Access Compliance Report Public Rights-of-Way (Curb Ramps)

Main Street: BELLFLOWER_ST Cross Street: TETHER_MOON_LN Location: SW

ADA ID: RPAT211101124530 Ramp Type: Type 4 - Parallel Initial Pass/Fail: Fail Overall Compliance: No Severity Score: 2

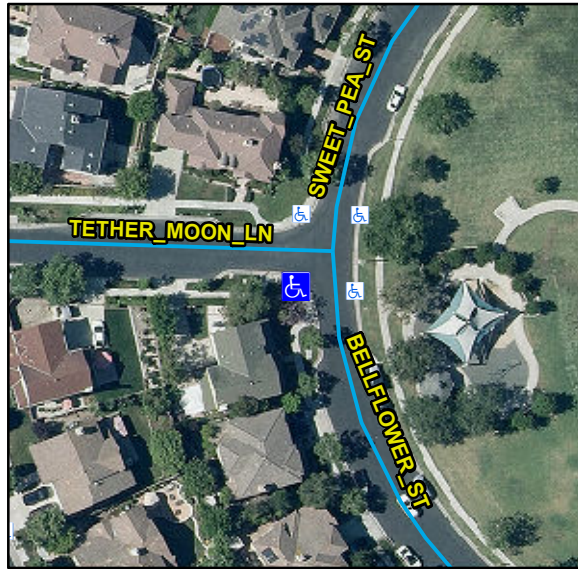
Compliance	Description	Data	Compliance	Description	Data
N/A	Ramp Length LT (in)	101	N/A	Ramp Length RT (in)	110
Yes	Ramp Width LT (in)	53	Yes	Ramp Width RT (in)	52
Yes	Ramp Run Slope LT (%)	5.3	Yes	Ramp Run Slope RT (%)	2.9
No	Ramp Cross Slope LT (%)	2.1	Yes	Ramp Cross Slope RT (%)	1.8
N/A	Landing Present	N/A	N/A	DWS Provided	N/A
N/A	Landing Length (in)	N/A	N/A	DWS Contrast	N/A
N/A	Landing Width (in)	N/A	N/A	DWS Length (in)	N/A
N/A	Landing Run Slope (%)	N/A	N/A	DWS Full Width	N/A
N/A	Landing Cross Slope (%)	N/A		DWS Offset Type	N/A
N/A	Landing Movement Obstructed?	N/A	N/A	DWS Offset Left (in)	N/A
	Landing Movement Type	N/A	N/A	DWS Offset Right (in)	N/A
N/A	Landing Shared	N/A			
N/A	Clear Space	Yes			
N/A	Clear Space To Crosswalk (in)	N/A			
N/A	Marked Crosswalk 1	No	N/A	Marked Crosswalk 2	No
	Crossing 1 Direction	E		Crossing 2 Direction	N
	Marked Crosswalk 1 Width (in)	N/A		Marked Crosswalk 2 Width (in)	N/A

Remove & Replace Curb Ramp With Two New Directional Ramps or Equivalent.

R204.3, R304.5.3, STD 1115
